ADDENDUM NO. 1

HC Wheatley Institute 3<sup>rd</sup> Floor

## **Project: Wheatley Institute – 3<sup>rd</sup> Floor Renovation**

### **ADDENDUM NO. 1**

**M9243 A6.1**

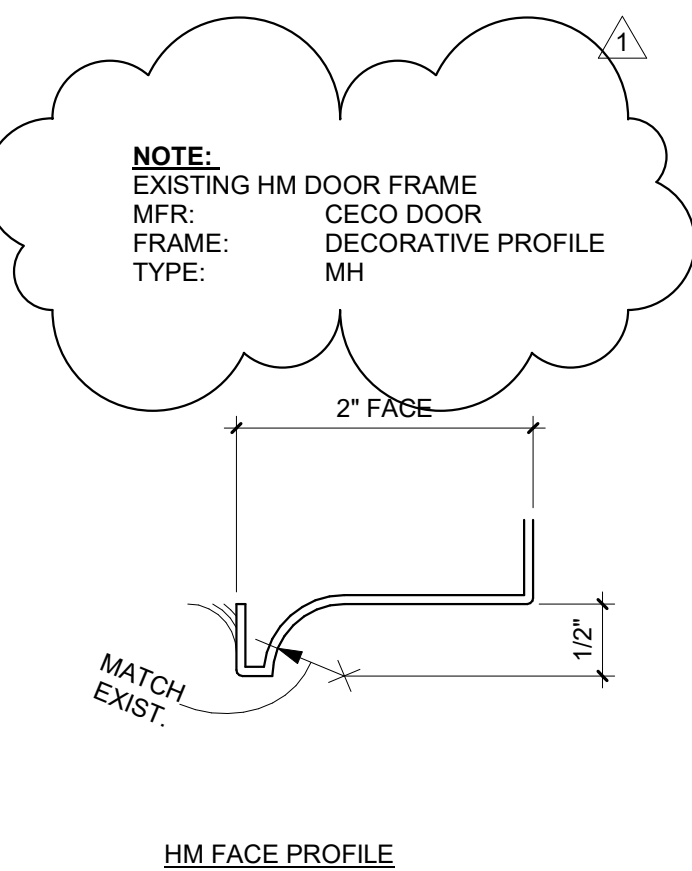
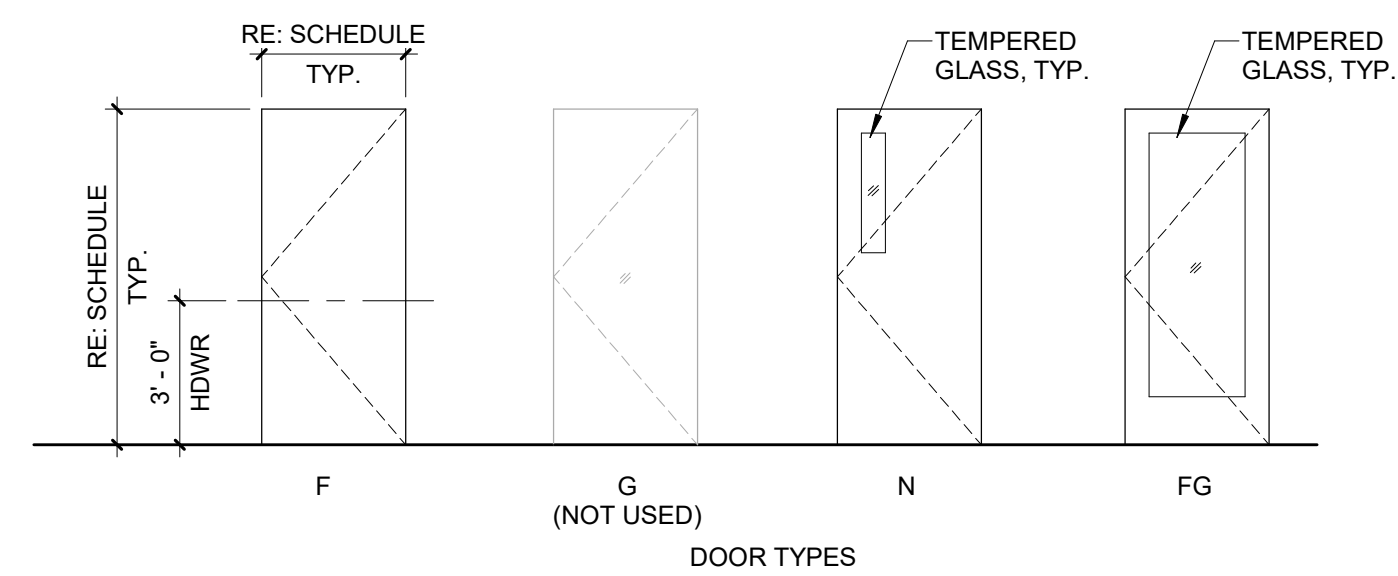
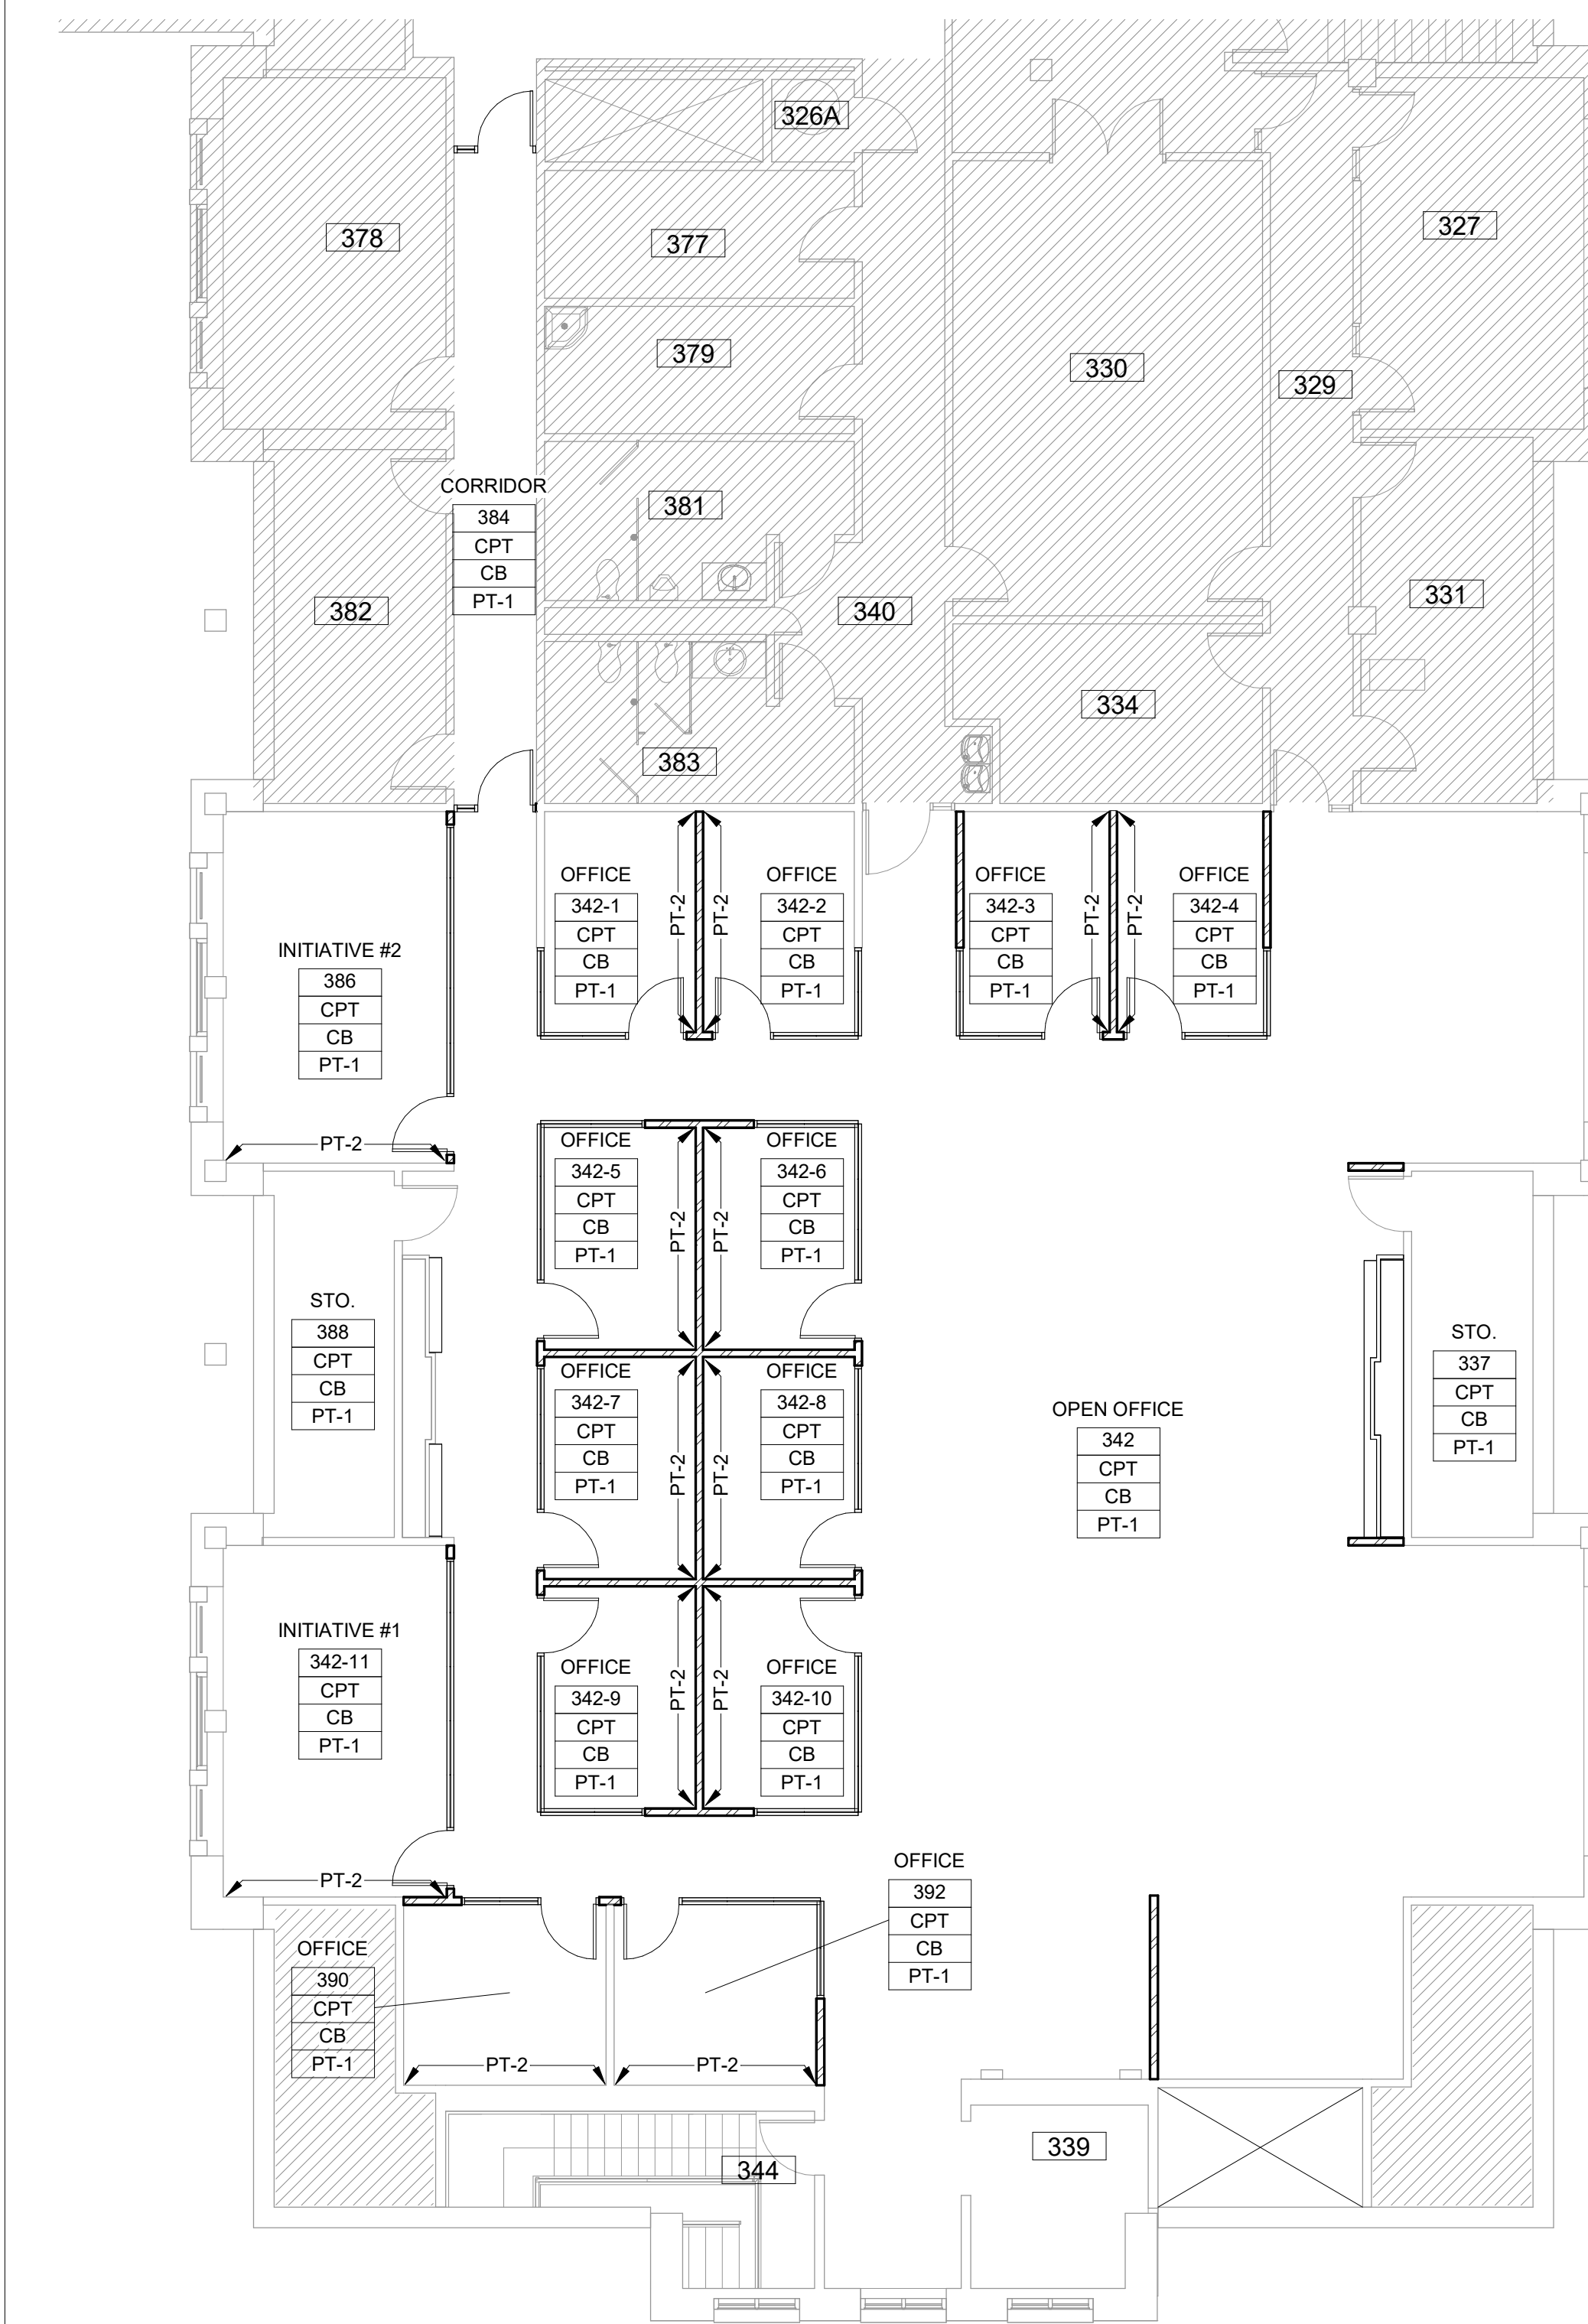
#### **7. Sheet A6.1:**

- REVISE: HM Face Profile detail to include information on the original frame manufacturer/supplier for the custom HM door frames as a reference.
- REVISE: Materials Finish Legend to include updated paint colors and solid surface countertops. – note Solid Surface counters will be Owner Provided and Owner Installed.

**HVAC CONTROLS DETAIL**

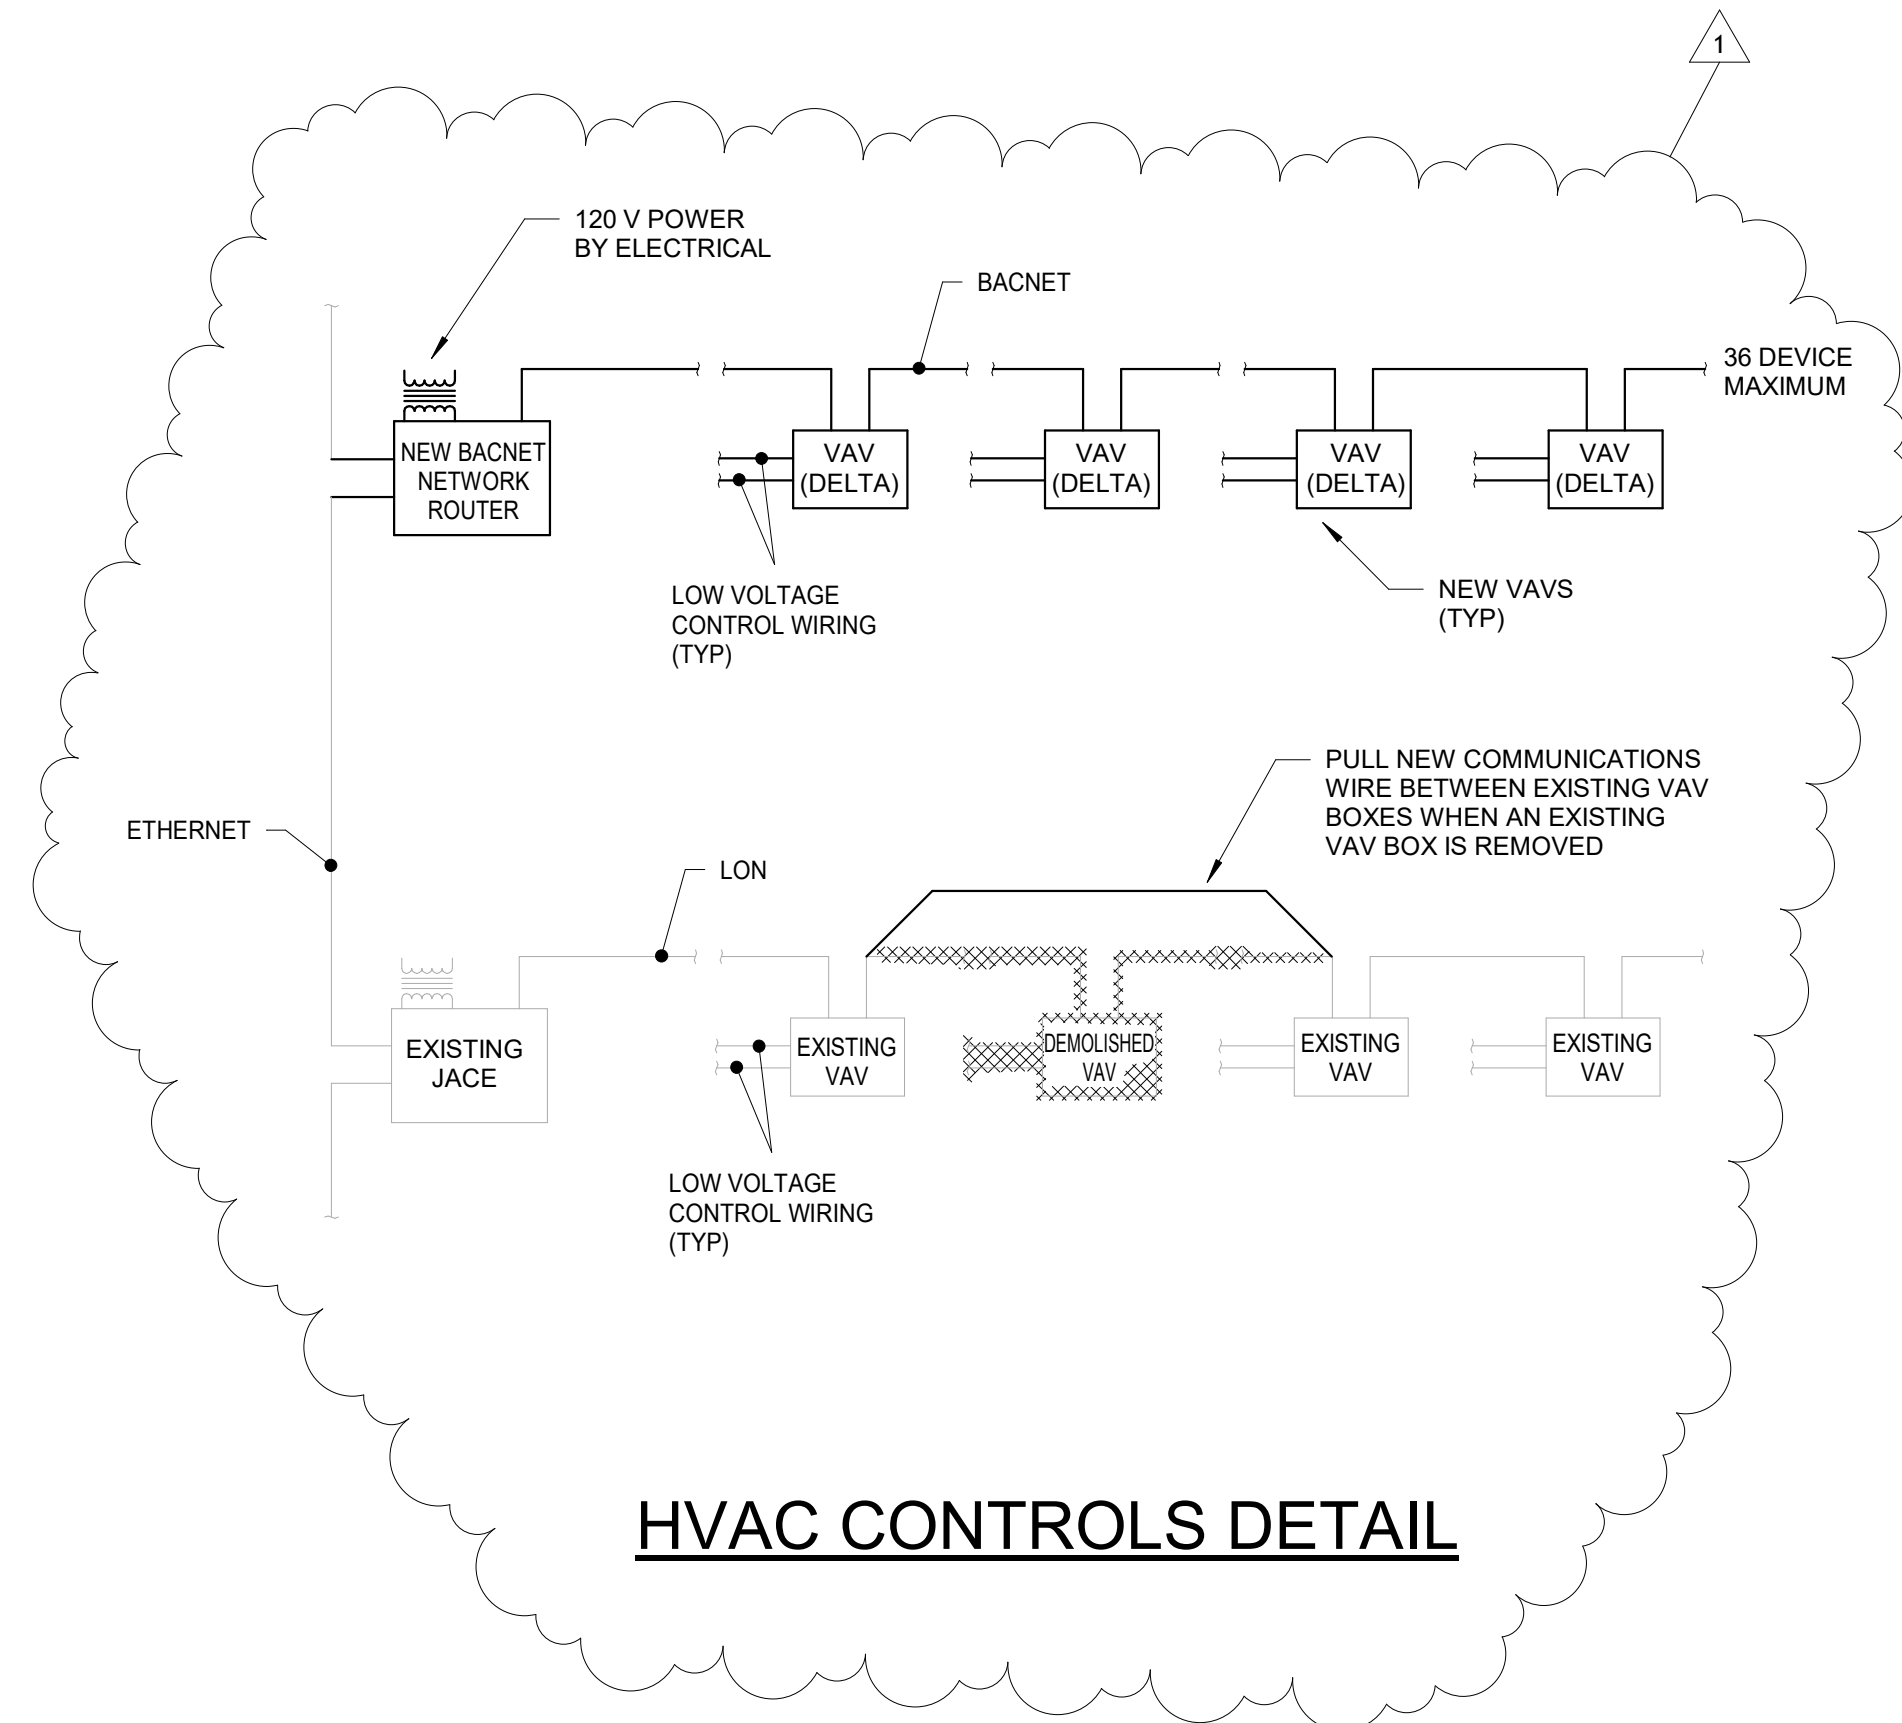
#### **8. Sheet M0.1:**

- ADD: HVAC Controls Detail to sheet.
